TRANS/WP.29/807  
3 August 2001

World Forum for Harmonization of Vehicle Regulations (WP.29)

DRAFT SUPPLEMENT 1 TO REGULATION No. 100

(Battery electric vehicles)

Figure 7.1  
Determination of hydrogen emissions  
during the charge procedures of the traction battery

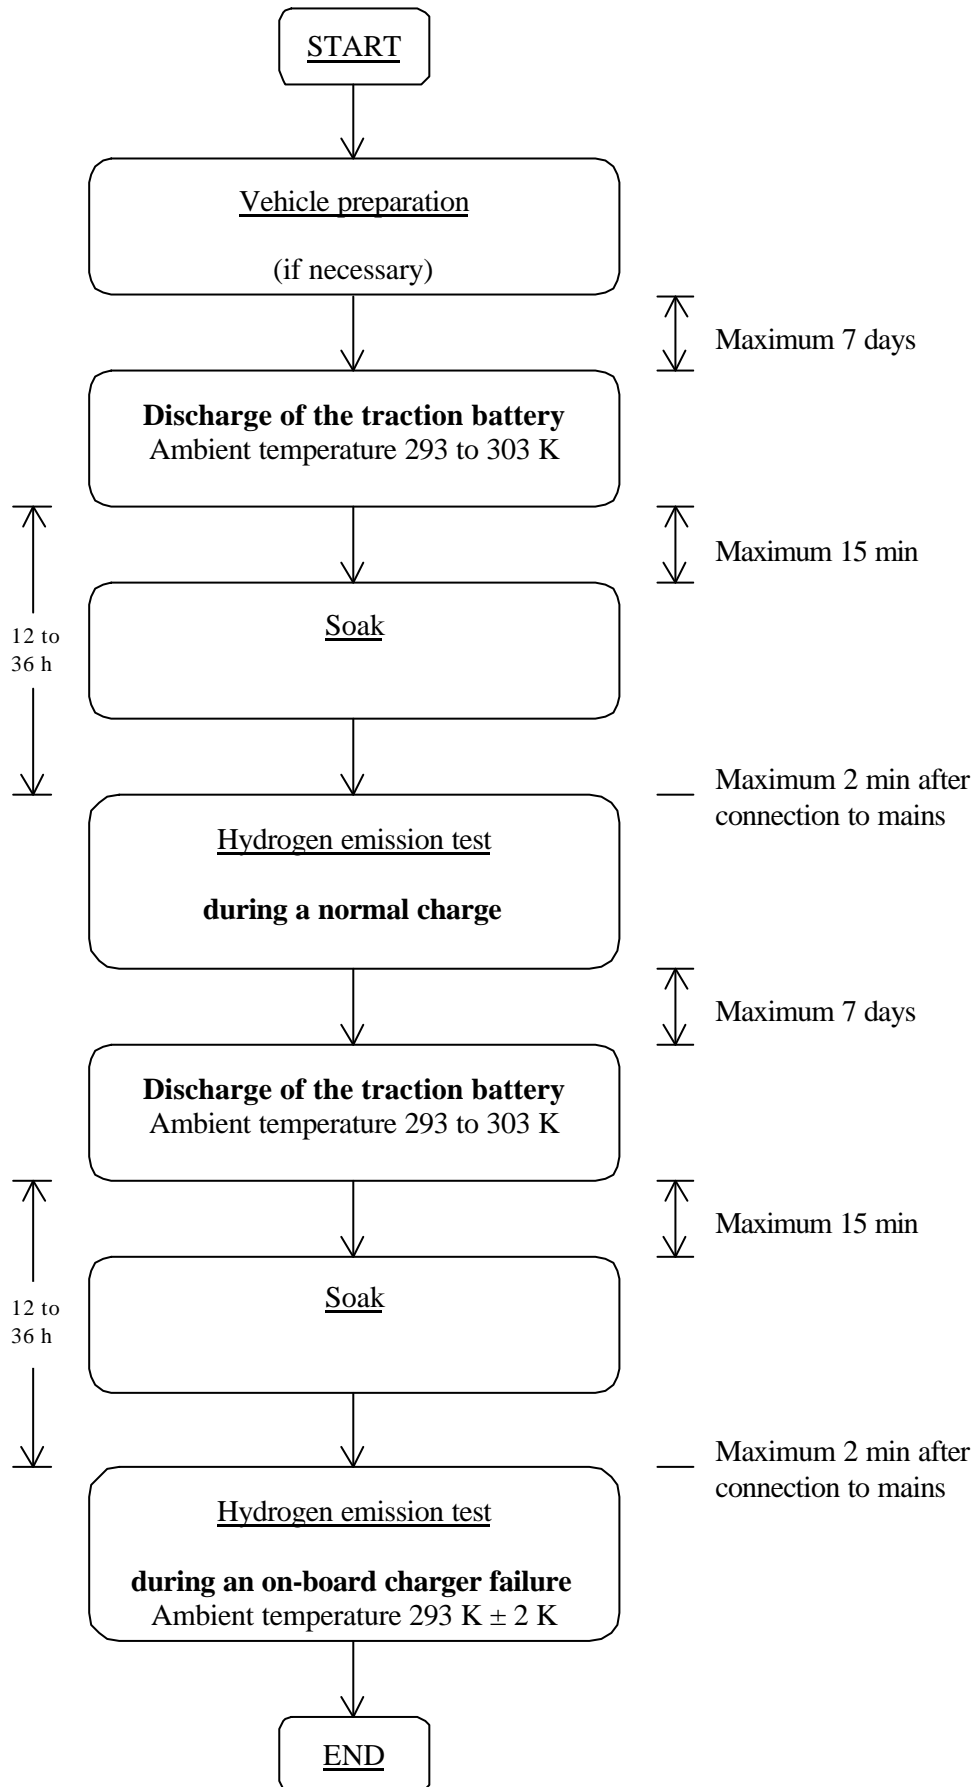
Insert a new Annex 7, with Appendices 1 and 2, to read:

The hydrogen emission test (Figure 7.1) is conducted in order to determine hydrogen emissions during the charge procedures of the traction battery with the on-board charger. The test consists in the following steps:
